Title: **STAGE 1&2 ROAD SAFETY AUDIT**

Belgard Gardens, Residential Development, Tallaght.

Client: **O'Connor Sutton Cronin**

Report reference: **0488R01**

3.1 Problem

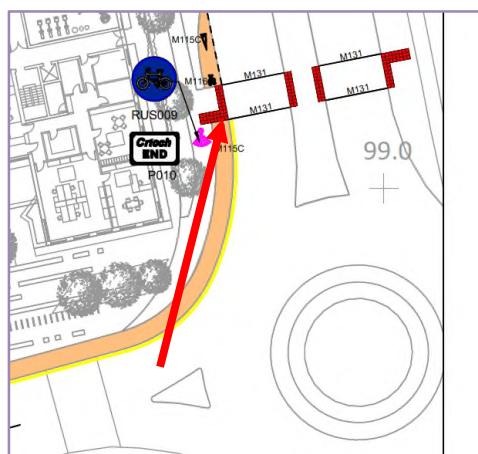
Proposed Toucan crossing on Belgard Road, North of the roundabout.

Drawing A557-OCSC-XX-XX-DR-C-1200 S3 rev P05

There is a risk that drivers of vehicular traffic turning left out of Belgard Square North at the roundabout on Belgard Road may not have adequate visibility to the proposed toucan crossing to the north of the roundabout and may have insufficient time to stop if a pedestrian or cyclist is crossing. This could lead to conflicts between vehicular traffic and vulnerable road users. In addition, vehicle speeds may be high on approach to the toucan crossing due to the straight and wide alignment of Belgard road and the geometry of the roundabout. Higher vehicle speeds lead to greater injury severity should collisions occur.

It is recommended that adequate visibility is provided to the crossing for left turning drivers from Belgard Square North. This includes the removal of any vegetation that could grow during summer months or due to lack of maintenance.

The signal heads for both the nearside and offside signals for northbound traffic should be easily seen by left turning traffic. (Note the position of signal heads have not been shown on the drawings provided)

It is recommended that the toucan crossing be raised similar to the uncontrolled crossing to the south of the roundabout to highlight its presence and provide traffic calming.

It is also recommended that a raised table is provided on Belgard Road North in advance of the roundabout to ensure slow entry and hence exit speeds from the roundabout.

3.1	Yes	No	<p>Measures 1, 2 and 3 are accepted. The raised crossing will be provided on the Belgard Road subject to detailed agreement with SDCC Roads Department.</p> <p>Measure 4 is not accepted. The scheme provides for very high quality landscaping along the northern side of Belgard Square North. It is the opinion of the Designer that this coupled with the active frontage of the Student Accommodation Entrance will sufficiently reduce speeds</p>	Yes

3.2 Problem

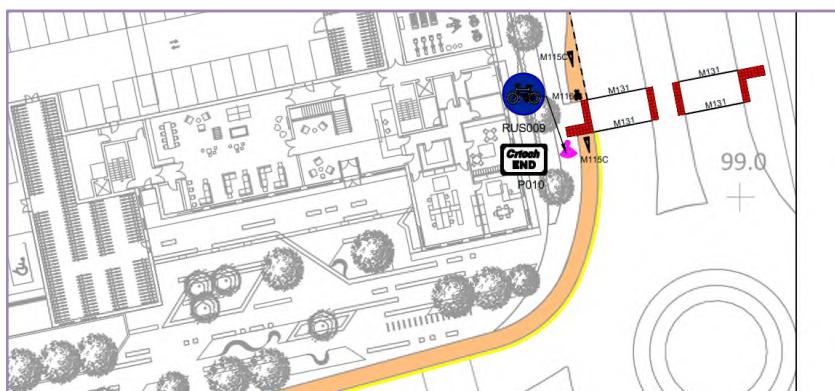
Proposed Toucan crossing on Belgard Road, North of the roundabout.

Drawing A557-OCSC-XX-XX-DR-C-1200 S3 rev P05

It is anticipated that there will be a high demand for cyclists using the proposed toucan crossing who will wish to travel from the new student accommodation to the ITT. There is a risk that the lack of connectivity with cycle facilities on either side of the toucan crossing will lead to collisions between cyclists and pedestrians. Cyclists will travel in both directions to take the shortest journey between the residential accommodation and the college.

It is recommended that two-way cycle facilities be provided from the ITT gates to the proposed crossing and that two-way facilities be provided from the crossing to the proposed development.

3.2	Yes	Yes	The crossing will be connected to the existing cycle facilities on Belgard Road.	Yes
3.3	Yes	Yes		
3.4	No	No	Moving the landscape and bio-retention zone further away from the road could make the road feel wider. This could result in higher speeds within the development and lead to more serious collisions occurring. On this basis the designer would prefer to maintain the current landscaping zone in the cross-section.	Yes

3.3 Problem

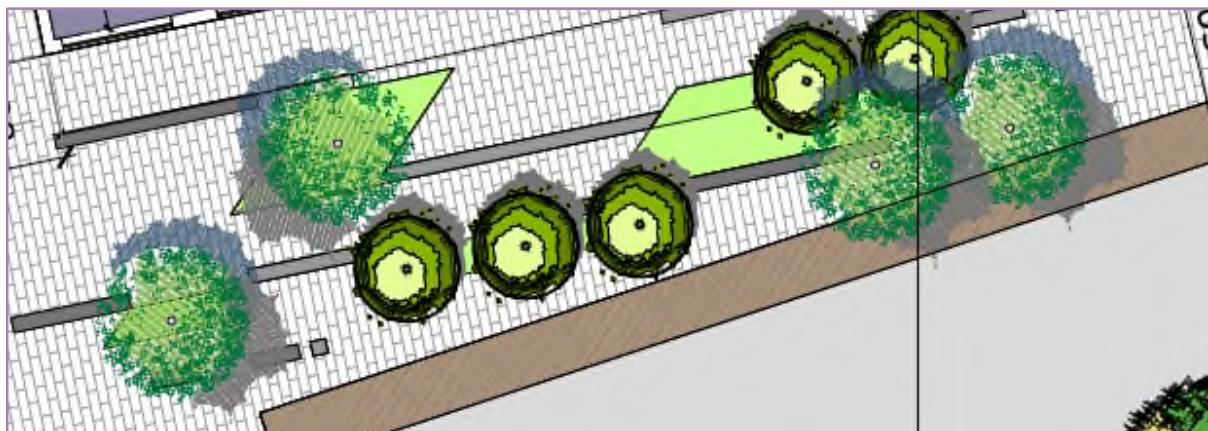
Drawing, Proposed Site Plan (O'Mahony Pike)

It is unclear if there is a clear route for blind or partially sighted pedestrians to navigate along the paved pedestrian space along Belgard Road North. A lack of space could lead to injury for such vulnerable road users if they collide with roadside furniture.

It is recommended that the paths for pedestrians along the northern side of Belgard North is easily navigated without obstruction and that it is of sufficient width.

3.4 Problem

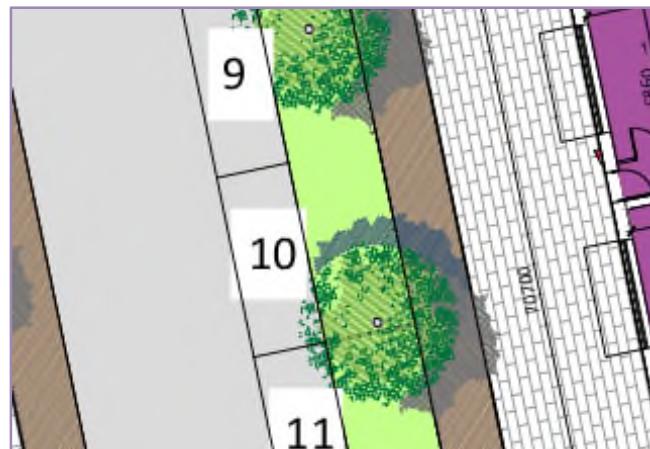
Internal Road, BL01, car parking.

Drawing, Proposed Site Plan (O'Mahony Pike)

It is proposed to have some parallel parking along the eastern side of internal road BL01. There is a grassed verge adjacent to the car parking spaces which could lead to slips and falls for pedestrians getting to/from their vehicles, especially in wet or icy conditions.

Provide a footpath to the rear of the parking spaces.

3.5 Problem

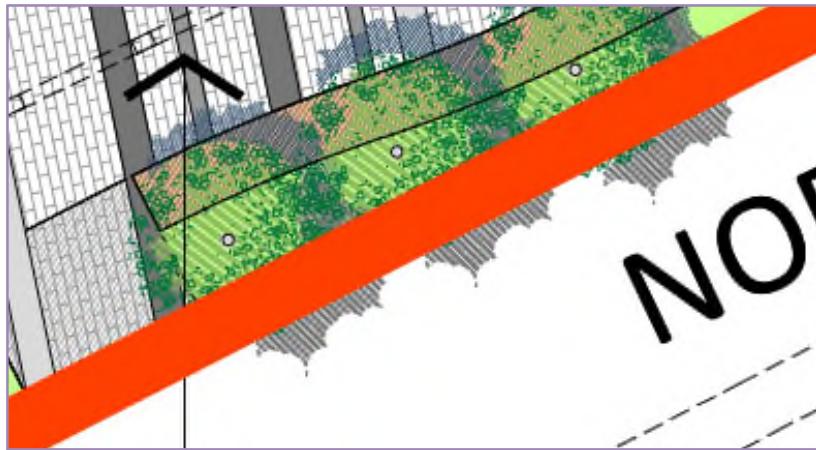
Trees along Belgard Square North.

Drawing, Proposed Site Plan (O'Mahony Pike)

It is proposed to have trees in the grass verge between the carriageway of Belgard Square North and the Cycle track. There is a risk that the canopy of the trees may overhang the cycle track and lead to potential injury for cyclists or may overhang the carriageway and be struck by passing vehicles including high sided vehicles (including buses)

It is recommended the trees of suitable girth and canopy are chose at these locations and if they cannot be accommodated that more suitable planting be provided.

3.5	Yes	Yes

3.7 Problem

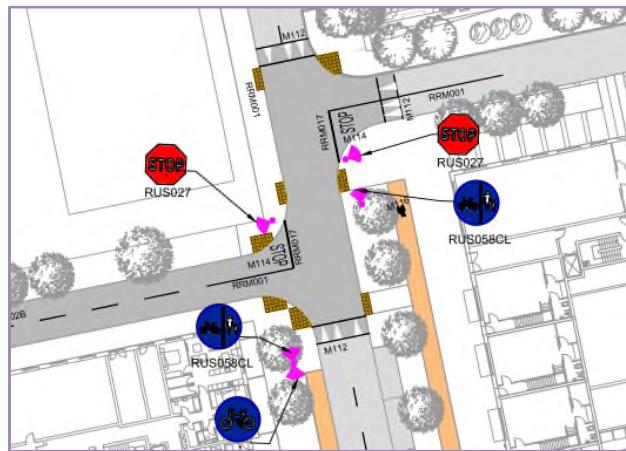
Internal Junction, BL01, BL02 & BL03

Drawing, Proposed Site Plan (O'Mahony Pike)

It is unclear how on-road cyclists on BL03 can access the cycle track along BL01 or how cyclists travelling along BL02 can access the cycle track along BL01 without conflicts with vehicles or pedestrians.

It is recommended that cyclists making manoeuvres in all directions have adequately wide cycle or shared facilities to avoid conflicts with other road users.

Paragraph No. in Safety Audit Report	Problem accepted (yes/no)	Recommended measure accepted (yes/no)	Alternative measures (describe)	Alternative measures accepted by Auditors (Yes/No)
3.6	No	No	As a clarification, the footpath width in this location is 4.5m wide. Given a mature tree width of 0.3m-0.5m, this leaves 1.75m-2.1m either side of the trees.	Yes
3.7	Yes	Yes	The internal area of the development, after the dedicated cycle facilities becomes a "Home Zone" type area, this is denoted by the raised area and the use of the large cycle symbol M116 on the carriageway. This will result in lower speed for vehicles as they enter this shared surface and will result in increased safety for cyclists.	Yes
